[Docket No. FAA-2004-19960; Directorate Identifier 2004-CE-47-AD]

Airworthiness Directives; The New Piper Aircraft, Inc. PA-34 Series Airplanes

ACTION: Notice of proposed rulemaking (NPRM).

Airworthiness Directives; Air Tractor, Inc. Models AT-502, AT-502A, AT-502B, and AT-503A Airplanes

Figure 1

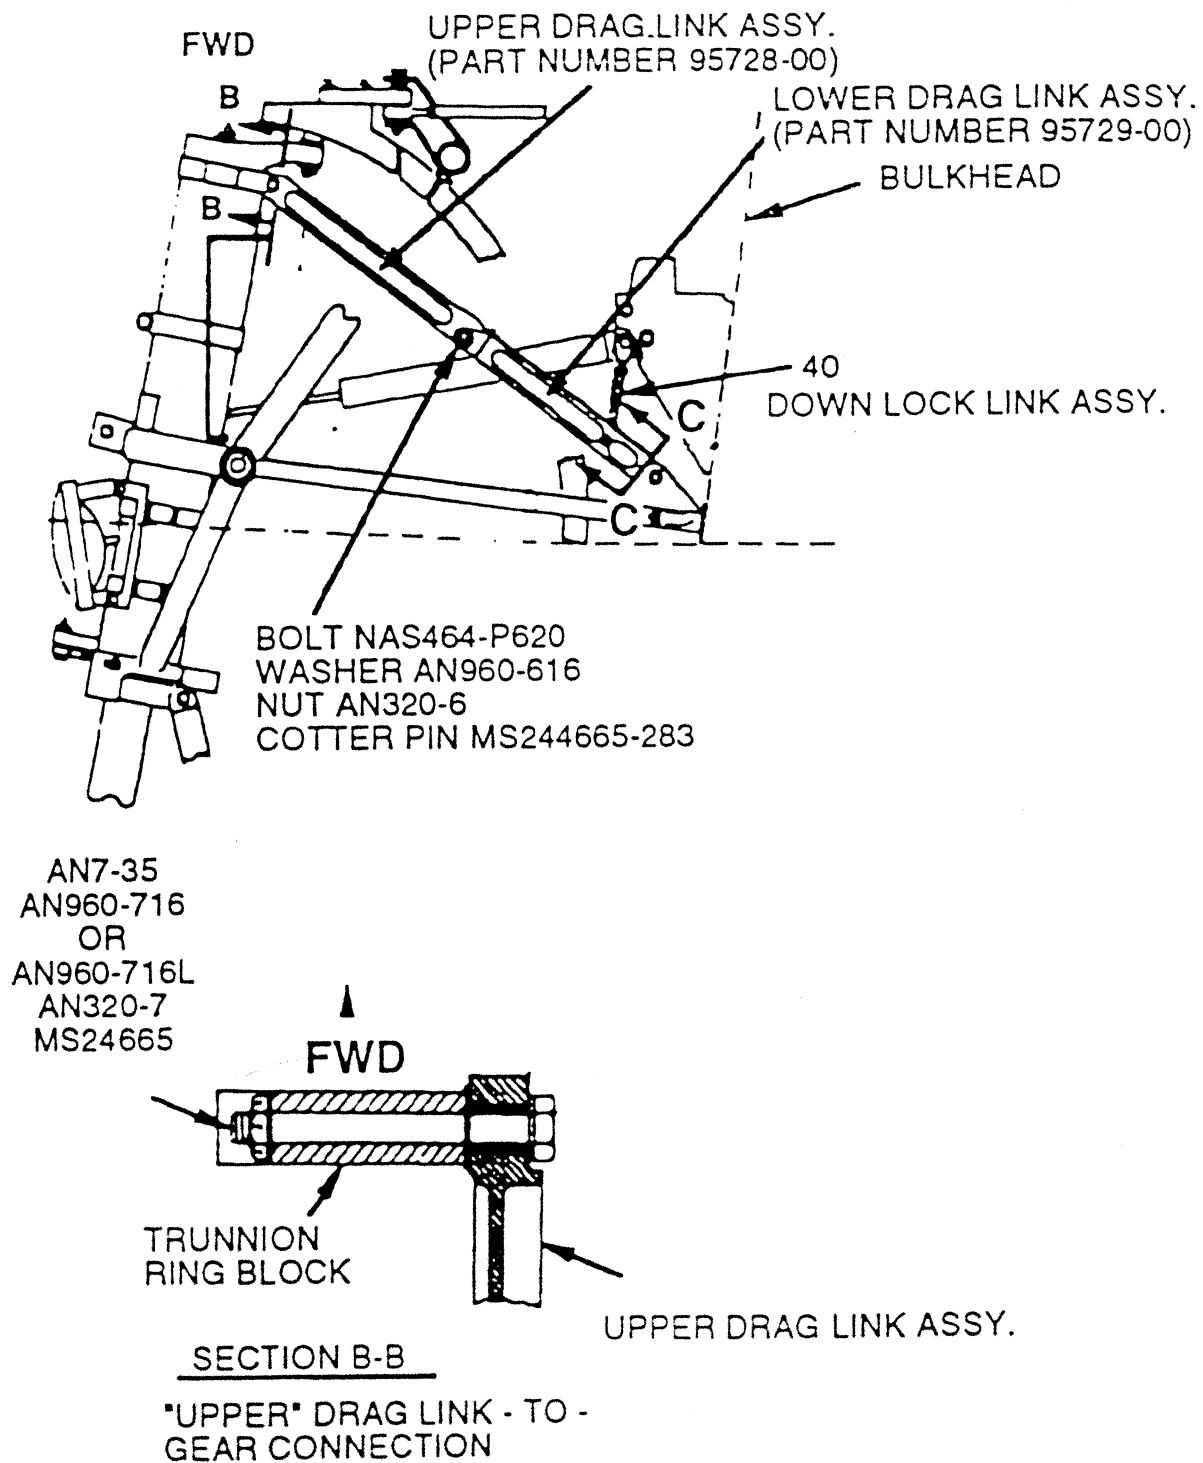
Actions	Compliance	Procedures
(1) Replace the bolt and stack up that connects the upper drag link to the nose gear trunnion with new parts of the following: (i) Piper part number (P/N) 400 274 (AN7-35) bolt; (ii) Piper P/N 407 591 (AN960-716L) washer, as applicable; (iii) Piper P/N 407 568 (AN960-716); (iv) Piper P/N 404 396 (AN320-7) nut; and (v) Piper P/N 424 085 cotter pin.	Within the next 100 hours time-in-service (TIS) after January 28, 1994 (the effective date of AD 93-24-14), unless already done within the last 400 hours TIS before January 28, 1994 (compliance with AD 93-24-14). Repetitively replace thereafter at intervals not to exceed 500 hours TIS. Continue to repetitively replace until the actions in paragraph (e)(2) and (e)(3) of this AD begin.	Follow Figure 1 of this AD.
